ADDENDUM NUMBER 1

MARCUS CENTER FOR THE
PERFORMING ARTS
HVAC RETROFIT PHASE 2 & 3
Site #270, Bldg. #50
929 North Water Street
Milwaukee, Wisconsin

Project Number: O038-09416-02

Date of Addendum: November 26, 2010

PROJECT 0038-09416-02
ADDENDUM NO. 1
DRAWING
SD-2

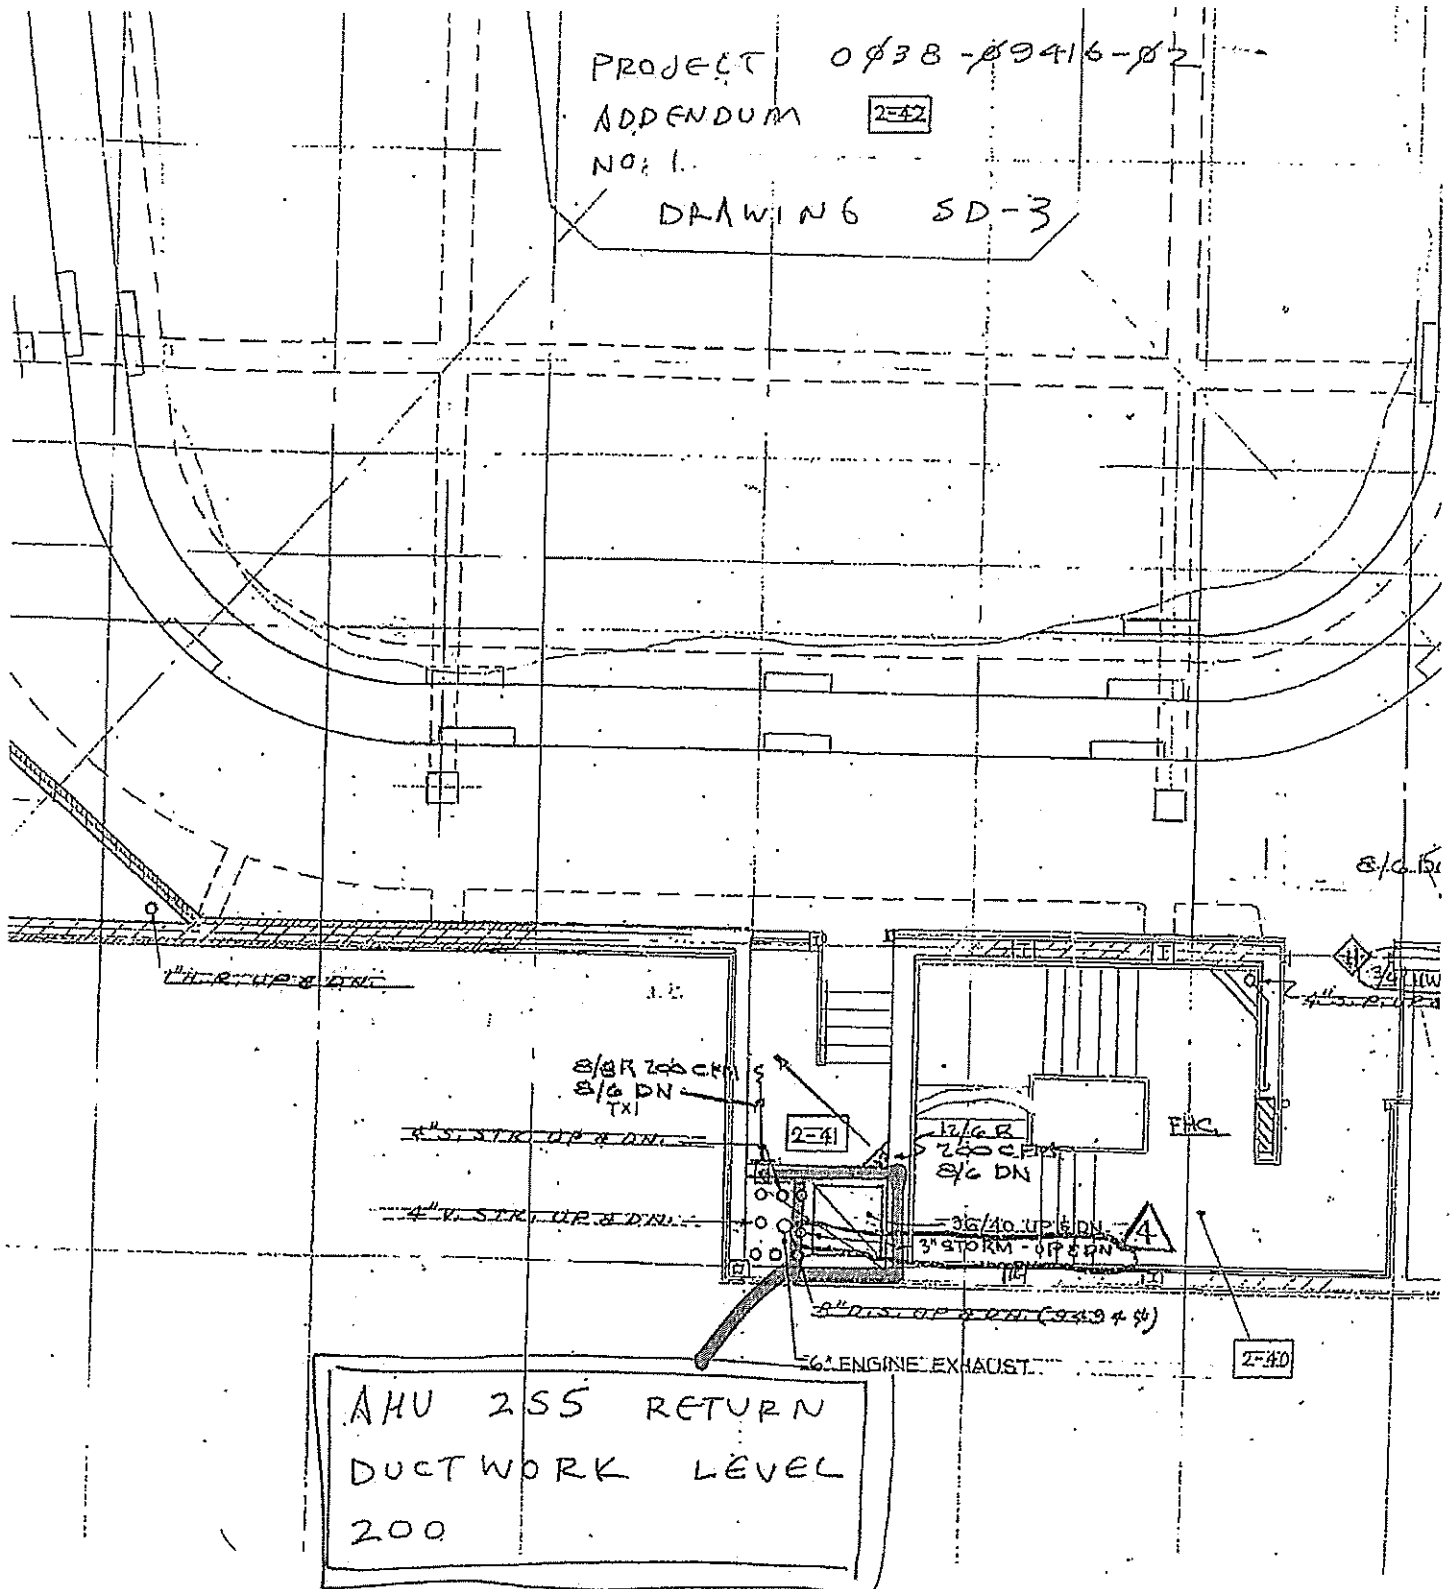
Supplemental Drawings: See the attached drawings (SD-1, SD-2, SD-3, SD-4, SD-5) for the extents of ductwork associated with Air Handling Unit 2S5 for the scope of ductwork cleaning.
